## Point-by-point replies to the referees' comments

Title: "Assessment of Short-medium Term Intervention Effects Using CAE2 SAR-Lisflood in Post-earthquake Mountainous Area"

Manuscript Number: nhess-2022-195

**Figure 1: The input rainfall series (a and b) and simulation results of the flash flood event in July 2018 (c and d).**

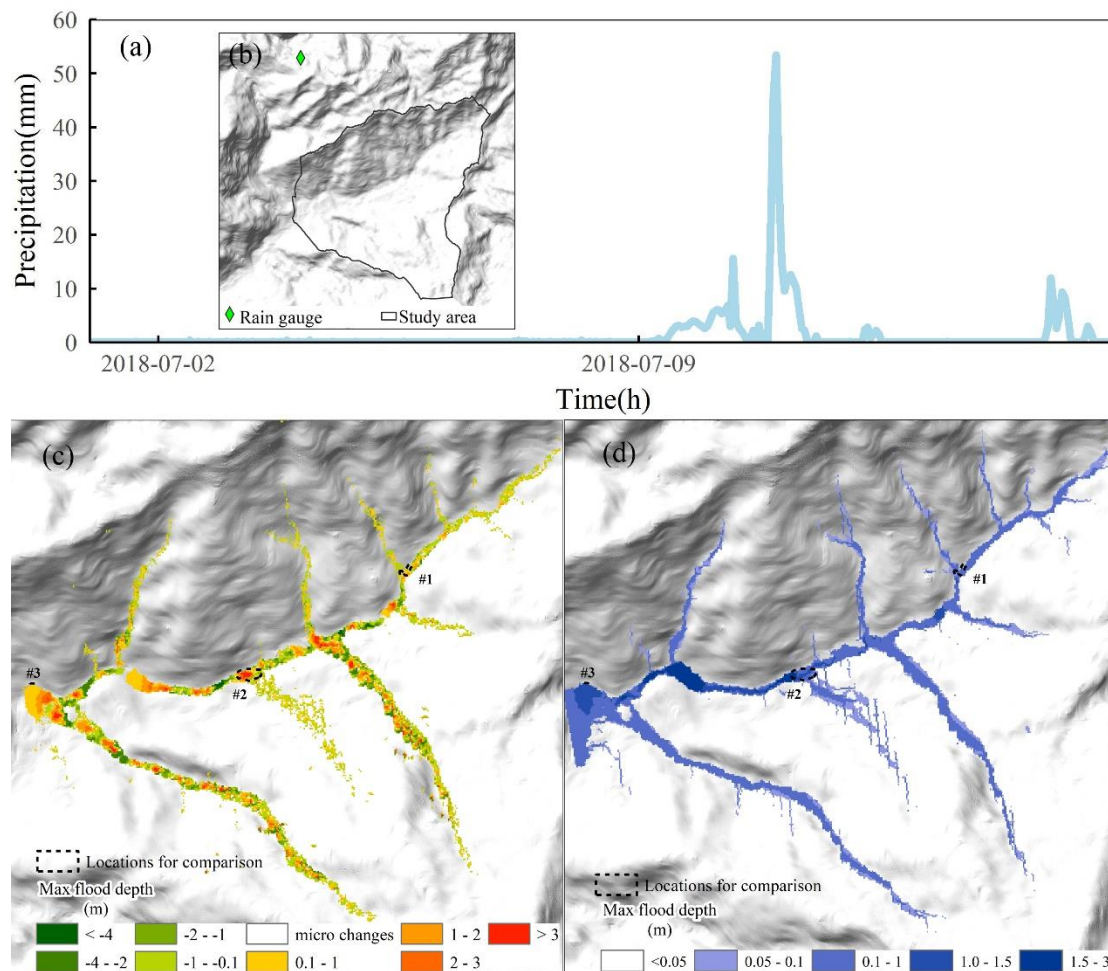
A weakness of the study is the lack of **calibration of the hydrological component in CL**. As such, there is no way of knowing if the quantity and timing of the floods in the ungauged catchment are accurately replicated by CL. The hydrological parameters adopted (m-values) are from studies performed from nearby catchments but these studies also have not performed calibration to derive m-values. The authors, instead rely on landcover to assign m-values, but **m-value is only partly dependent on landcover**. For example, Ramirez et al.2022 found that in a mountain catcInstitute’sdeESRI’srrelated **well with m-value** and not with landcover. To have greater confidence in the model, the authors need to provide **hydrographs for the entire simulated period** and, in addition, provide qualitative or quantitative data that confirms the physical plausibility of the simulated discharge, specifically the floods.

Admittedly, it is not enough for our calibration work to reference the parameters from the published research in the same catchment and use the recommended values by model developers. Considering the ungauged basins before 2015, we replicated the flash flood event in July 2018 by C-L to calibrate the hydrological components.

There are no considerable differences in geomorphology, channel location, and land cover before 2013 and after 2018 in our catchment found from the field surveys. Based on Scenario PP (with two check dams), we changed the rainfall series to the two-week hourly precipitation in July 2018, which is recorded by the rain gauge 2.5 km away from the catchment placed in 2015. The simulation results (Figure 1c and Figure 1d) showed the erosion and maximum flood depth deposition distributions in Scenario PP on July 15<sup>th</sup>, 2018. As shown in Figure 1c and Figure 1d, we selected three locations randomly to compare the simulation results with remotely sensed images and photos. The results (Figure 2) showed reliable results, including sediment deposition and the peak flood depth, which indicate that the flash flood event was replicated successfully by the C-L.

**Figure 3: (a) The simulation discharge in 2011-2013 in Scenario PP; (b) the verification location; (c) the comparison of the simulated to the recorded discharge.**

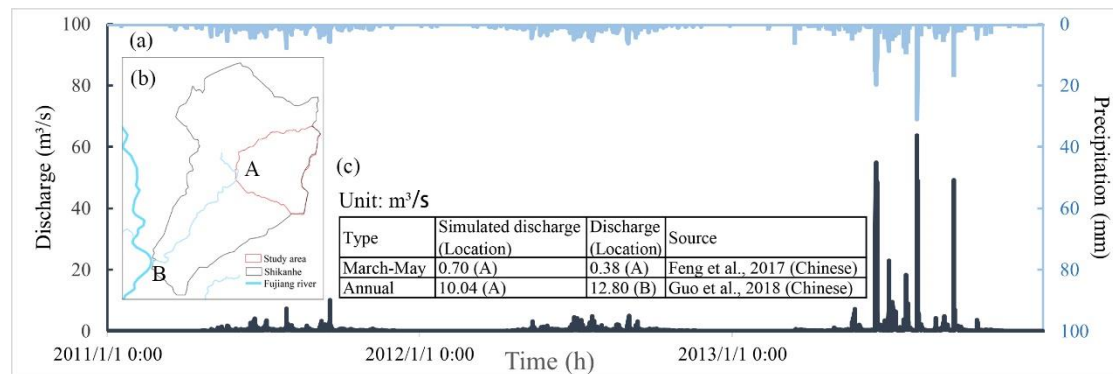
A **verification of the model outputs** for the PP scenario by comparing them to real-world observations would strengthen the analysis of the paper. For example, Figure 10 and related discussion could be

In section 5.1, we confirmed the plausibility of the simulated results using deposition depth evaluated from photos. Herein, we add the discharge of the entire simulation period for Scenario PP. As shown in Figure 3, we compare two types of discharge recorded in published research (Feng et al., 2017; Guo et al., 2018) with those of simulation results to confirm the physical plausibility. And we captured five flood events where the daily precipitation was more than 50 mm in 2013, and the peak discharge was up to  $63.6 \text{ m}^3/\text{s}$ .

Similar to the reply in section 3 and 5, we add the verification in the discharge and erosion/deposition at crucial spots. As shown in Figure 3, we compare two types of discharge recorded in published research (Feng et al., 2017; Guo et al., 2018) with those of simulation results to confirm the physical plausibility. As shown in Figure 4, we verify the erosional and deposited features by providing photographic evidence from the observed landscape and compare them with cross-sections from the simulated results.

**Figure 4: (a) Simulated geomorphic changes over time for three scenarios; (b) the exposure area included deposition and erosion for three scenarios; (c) the distribution of deposition and erosion at the conclusion of the simulation for the three scenarios.**

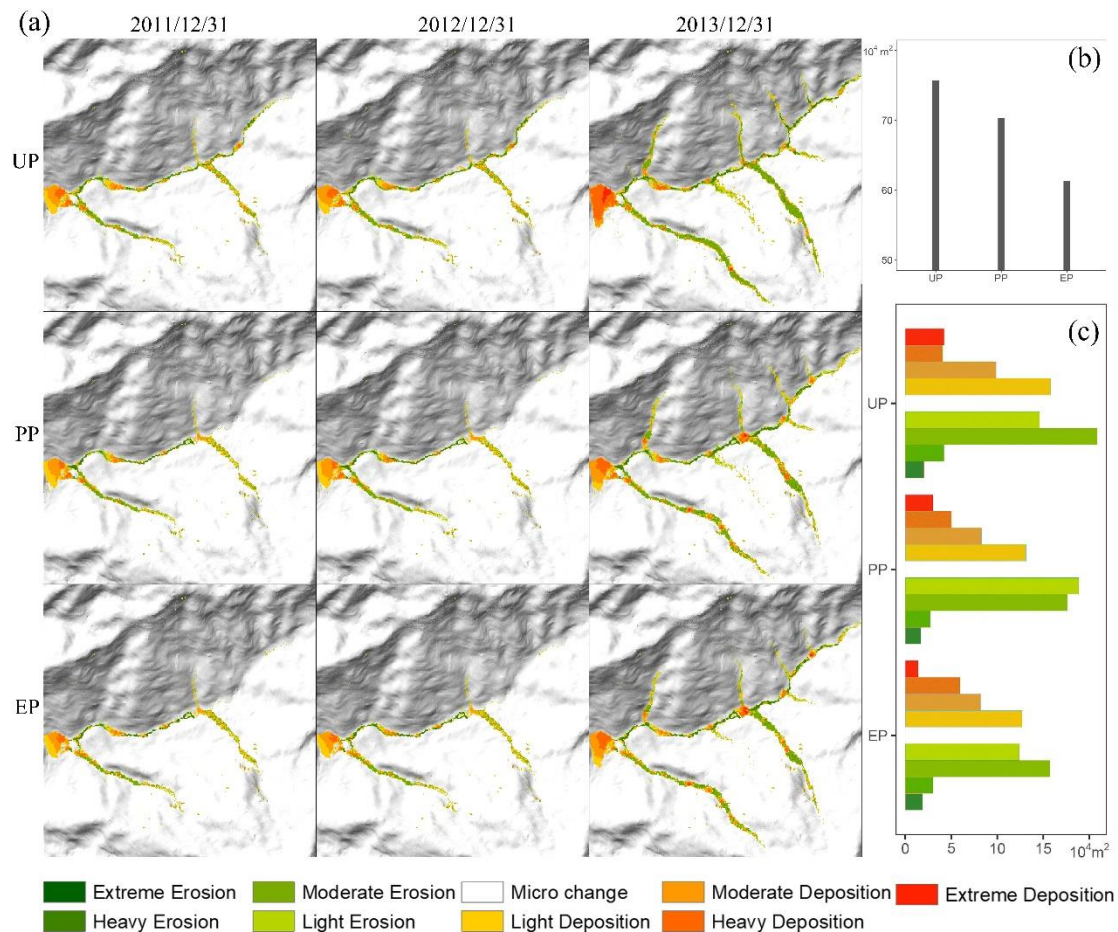
In this study, CL simulations have produced locations of deep erosion between 3-10 m in a period of three years. This is quite a bit of erosion in such a short period and in some instances would produce features in the simulated landscape that resemble small canyons. Could you **verify that these erosional features are physically plausible** by providing photographic evidence from the observed landscape and comparing them to cross-sections from the simulation? Or provide any other type of validation that

supports such extreme erosion across the simulated landscape. In addition, across all simulations (Fig. 5a), there are instances of erosion that exceed 3 m in the downstream area where erodible thickness is 3 m. Can the authors explain how **simulated erosion can exceed the thickness of the initial erodible sediment**? Likewise, in this study, how is it possible for CL to produce erosion between 10 and 15 m, if the maximum depth of erodible sediment in the catchment is 10 m?

Many thanks for your reminder, and we apologize for our mistakes in showing the abandoned simulation result, where the input based DEMs were generated improperly. Now we update the revised figures as shown in Figure 4 and Figure 5, showing the spatial distribution of erosion and deposition. We correct the description (extreme erosion (<-7 m), heavy erosion (-7--3 m), moderate erosion (-3--1 m), light erosion (-1-0.1 m), micro change (-0.1-0.1 m), light deposition (0.1-1 m), moderate deposition (1-3 m), heavy deposition (3-7 m), and extreme deposition (>7 m)) in section 4.1 and 4.2. After checking all the figures, tables and numbers, we ensure that all the analysis results and input parameters are consistent and from our optimal simulation.

**Figure 5: Geomorphic changes at the conclusion of the simulation at key spots for the UP, PP, and EP scenarios. The top row is the upriver section containing dam 1, dam 2 and the vegetation revetment. The bottom row is the downriver section containing levees.**

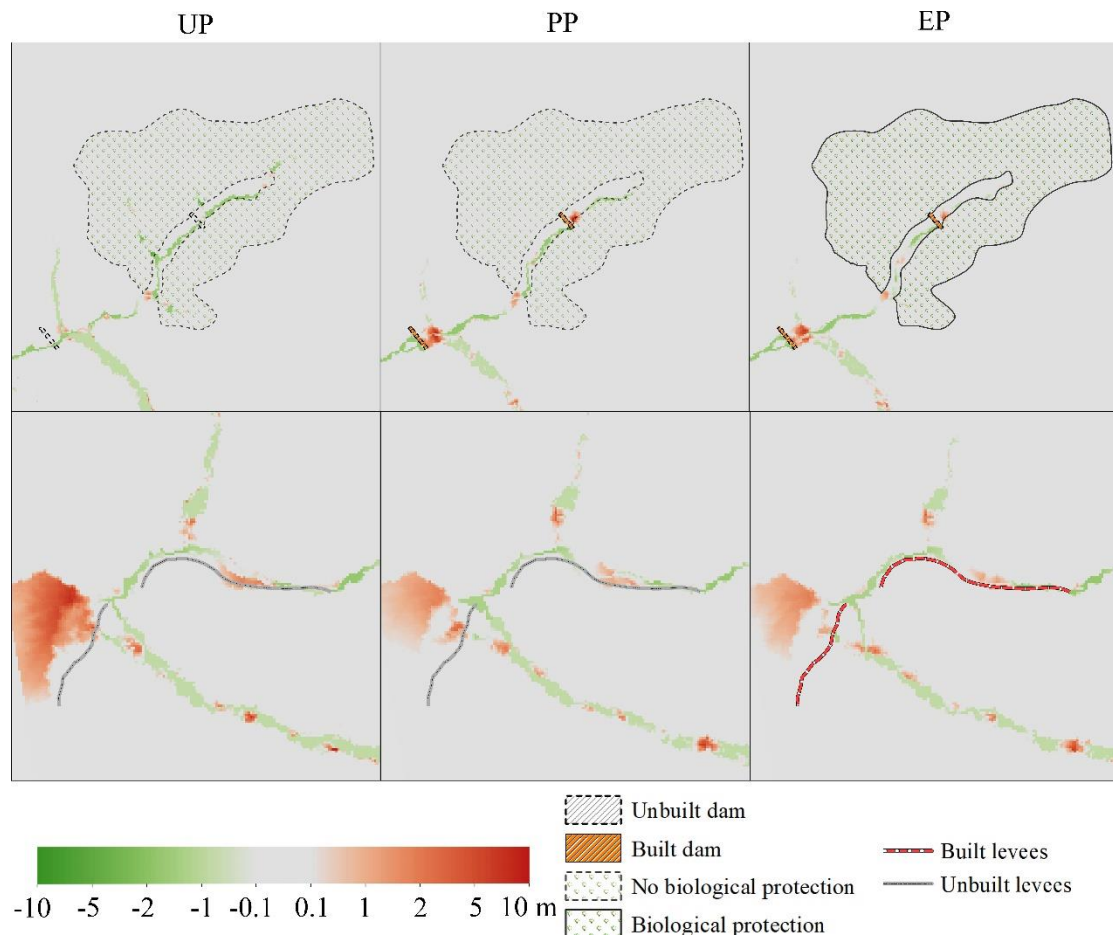
In Figure 6, the EP map shows the levees blocking a tributary, is this a mistake in the figure or did you really block this tributary in the simulation. Please explain.

We have checked carefully and ensured that the levees did not block the deep and narrow outlet of the

tributary.
